MEMORANDUM

Elliott House Rehabilitation [1904 North Heliotrope Drive, Santa Ana]
Project Compliance Analysis [U.S. Secretary of the Interior Standards for Rehabilitation]

13 November 2023

Image 13: Spalling [including losses] was observed where the railing penetrates the concrete coping.

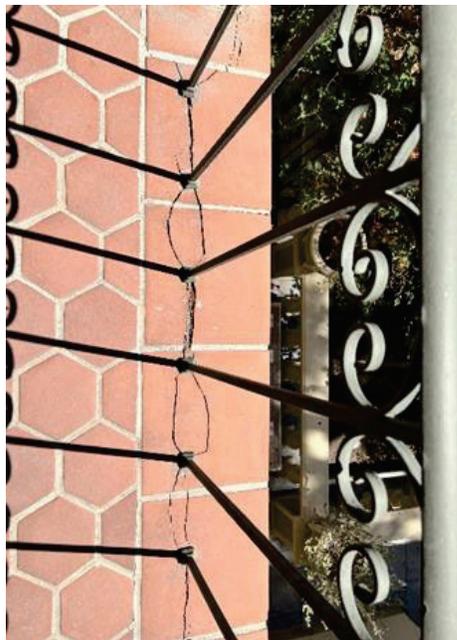
While the balcony decorative wrought iron railings appear to be in relatively good condition, they do not conform to today's safety regulations in both its height and openings. Failure of the existing paint coating was also observed throughout. The existing coating also contains lead. Oxidation has occurred where the railing penetrates the coping edge, resulting in spalling of the adjacent concrete decking. Previous repairs to the terra cotta paving have resulted in negative sloping of the deck preventing proper runoff of moisture from the deck surface.

Modifications will include the addition of supplementary railing elements to increase the overall rail heights while also decreasing the size of the existing openings. Additional pickets will be placed within existing gaps between the decorative scrolls and the length of the balusters will be increased though adding additional material. Knuckles will be used at the joints where the additional material is added to demarcate the original length of the balusters. A base rail will also be added in order to minimize the number of penetrations into the decking, significantly reducing the opportunity of spalling of the terra cotta deck.

Image 18: The existing rear stoop has been modified through an application of field stone paving.

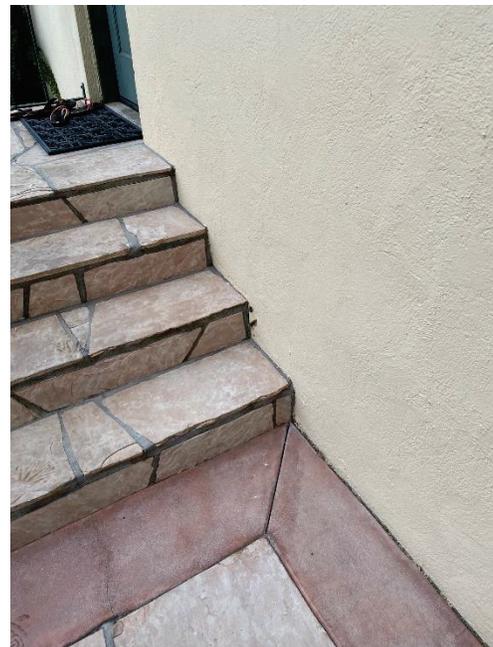
An existing stoop is present at the rear entry to the home. As no original architectural drawings of the home are known to exist, it is not known if the existing stoop dates from or reflects the original design. While the existing metal handrail may be original to the home, it differs in that it is simpler in design and construction than those located on the home's balconies. Flagstone veneer has been applied to all of the surfaces of the stoop [landing, treads, risers and sides], which is inconsistent with both the style and era of the home.

The existing stoop has been modified over time. The flagstone finish is inconsistent with the home's style and era of construction. The character of the existing stoop appears to be later than the home's construction, is inconsistent with the property's Italian Renaissance revival style, and lacks evidence of possessing historic significance in its own right.

The project scope includes removal/replacement of the existing stoop. The replacement stoop will be similar to the existing in its overall form, but includes stairs on both the north and south sides of the landing. This change will provide improved access to the rear yard and pool. A solid wall finished in stucco [to match house] will form the outer rail at the landing. Wall mounted iron handrails are also proposed. The landing, treads and risers will be natural, exposed concrete.
